Re-Bid Addendum No. 2

Project : **DNR- 230014.03**

FY23-24 Buck Creek State Park – New Nature Center

To All Bidders: This Addendum updates the Drawings and Project Manual designated “**RE-BID SET**” dated: **February 6, 2024**. Content within this Addendum shall become part of the Contract Documents.

1 GENERAL ELECTRICAL DEMOLITION PLAN
E-1-0 1/8" = 1'-0"

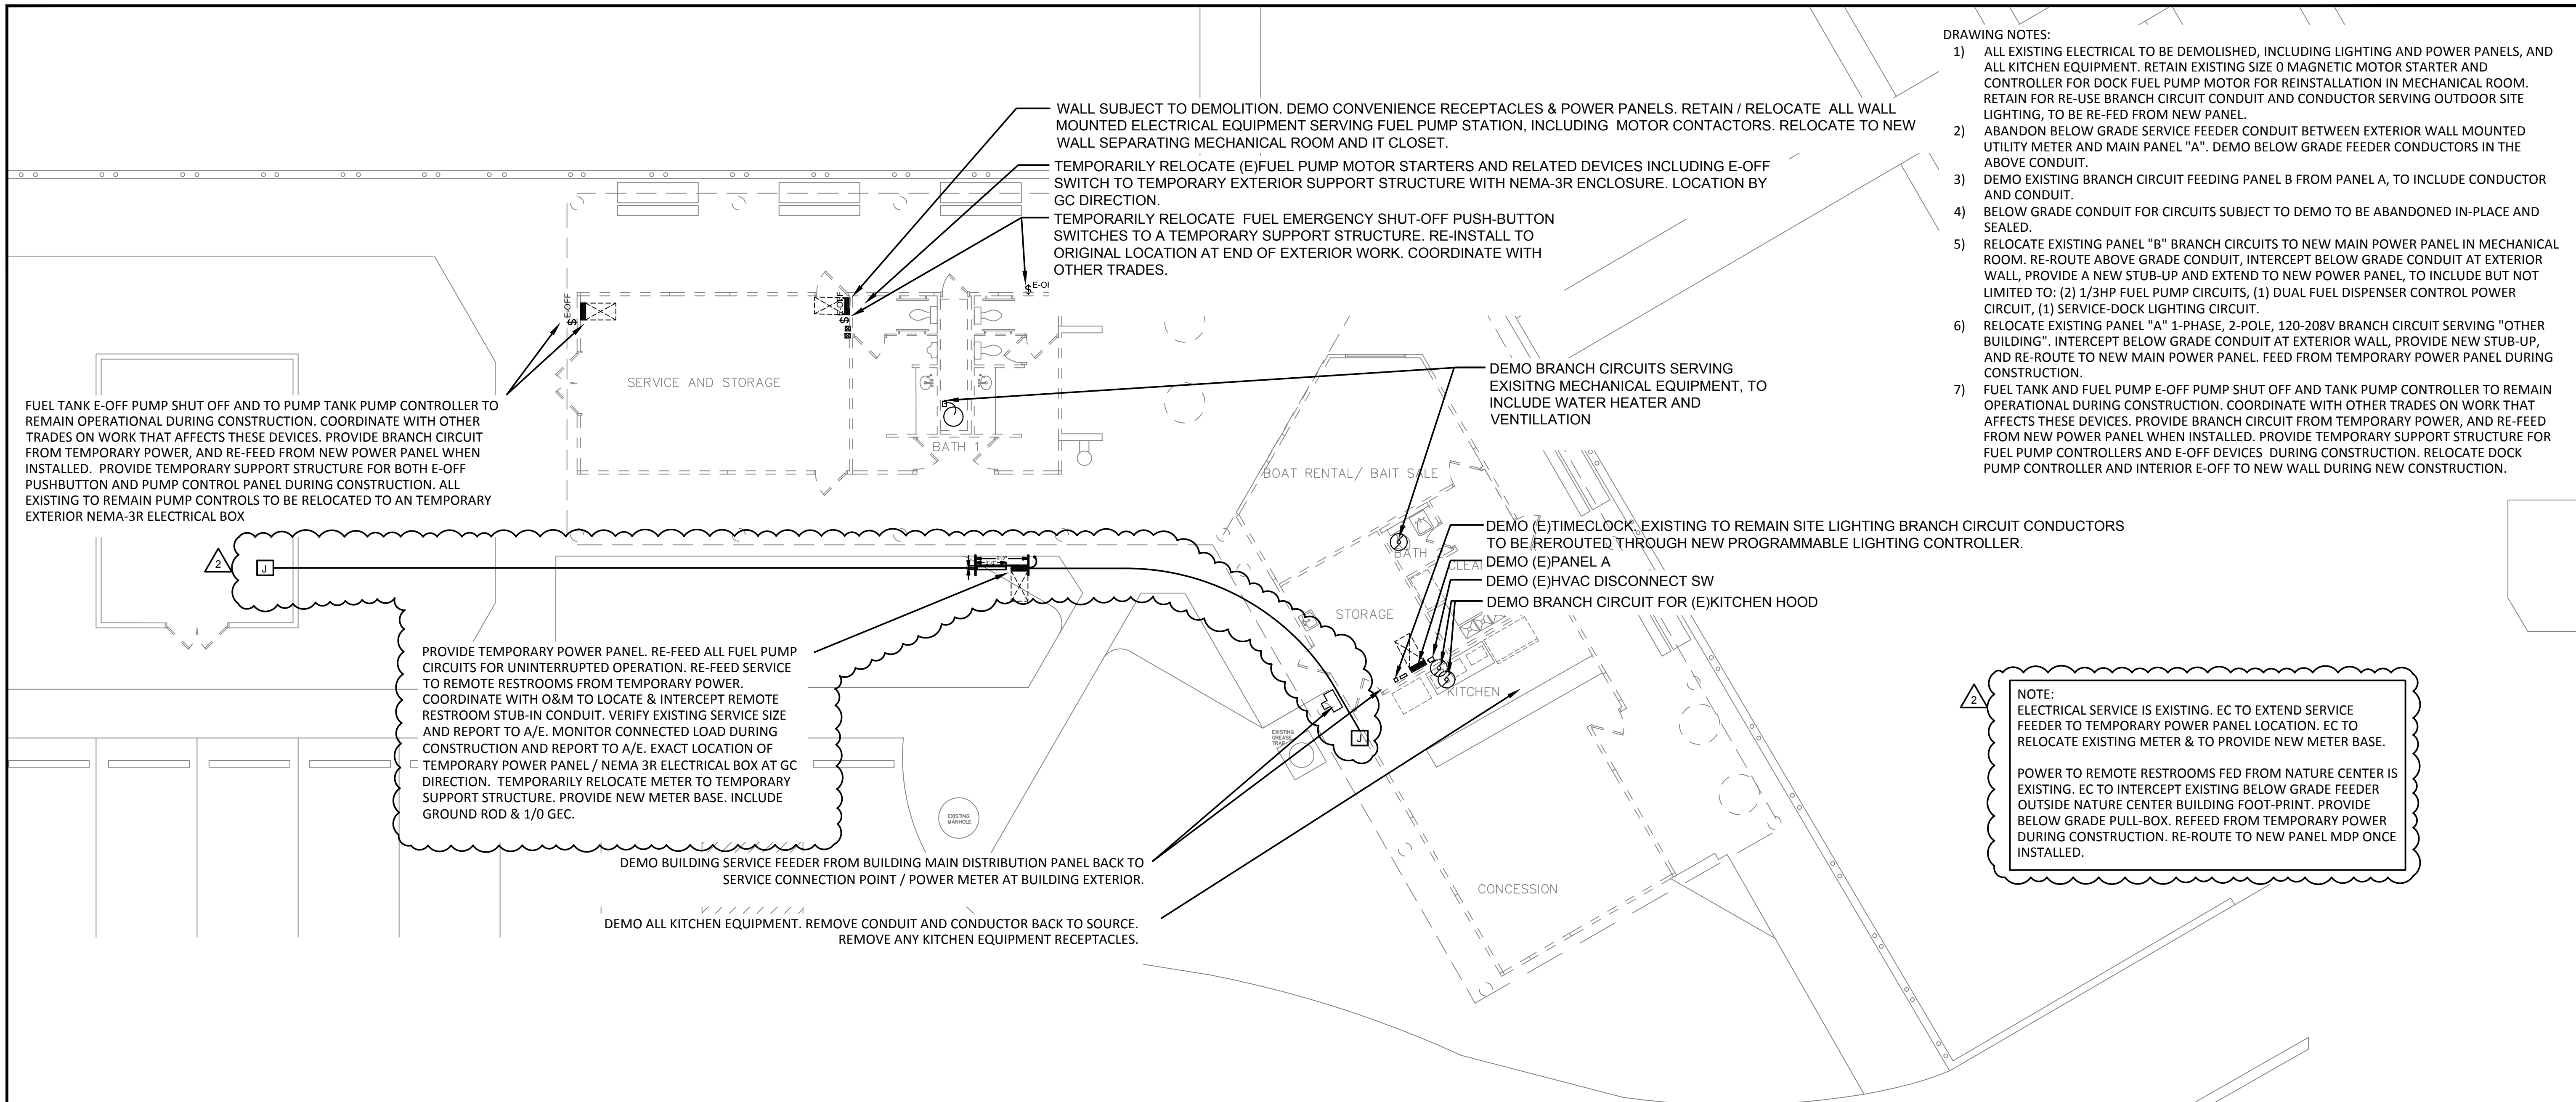
Re-Bid ADD2.4: REVISE Drawing E-1-0 -- GENERAL ELECTRICAL DEMOLITION PLAN as follows:

1) Revised sheet leader describing installation of temporary power panel and NEMA 3R junction box for fuel pump controls.

2) Added electrical cable routing path between existing service entrance and fuel storage area for temporary power and fuel pump controls.

3) added boxed note describing scope of work on relocation of meter and maintaining power to remote restroom via existing to remain feeder.

1 ELECTRICAL POWER PLAN
E-2-0 1/8" = 1'-0"

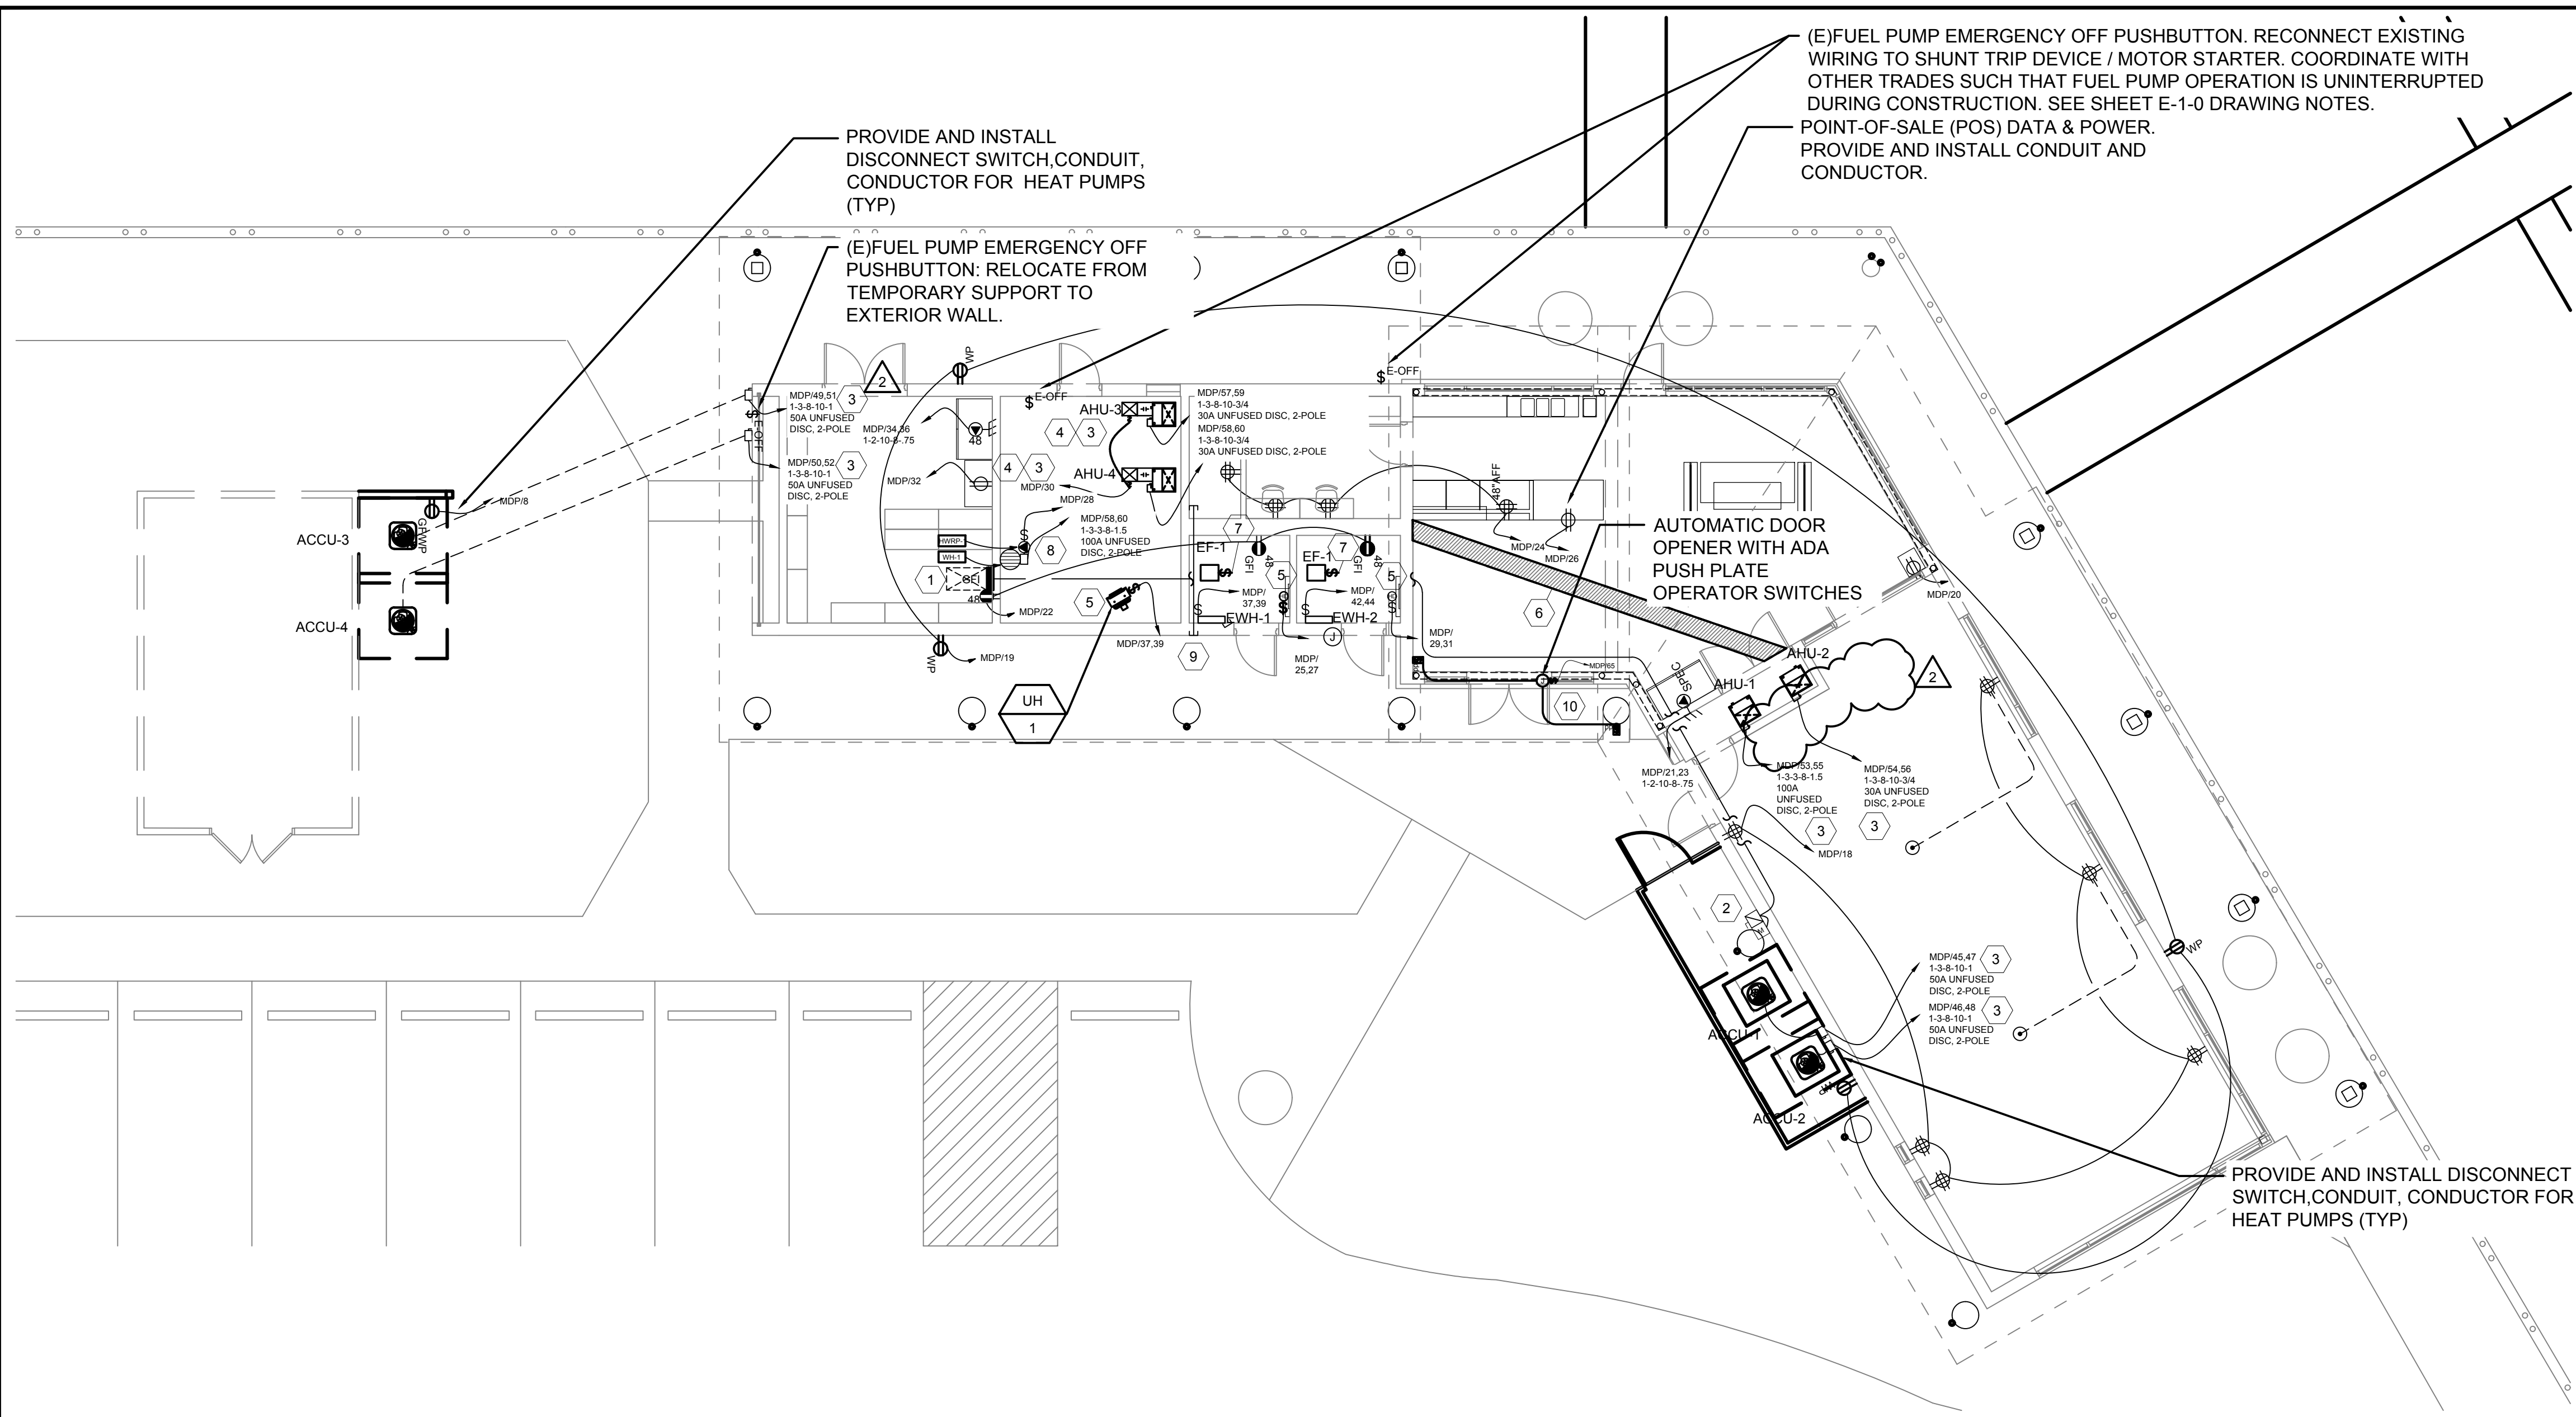
Re-Bid ADD2.5: CLARIFICATION to Drawing E-2-0 -- ELECTRICAL POWER PLAN:

1) Removed 24v HVAC control transformers and related motor contactor from electrical power plan.

2) Removed coded note 2 referencing 24V transformer.
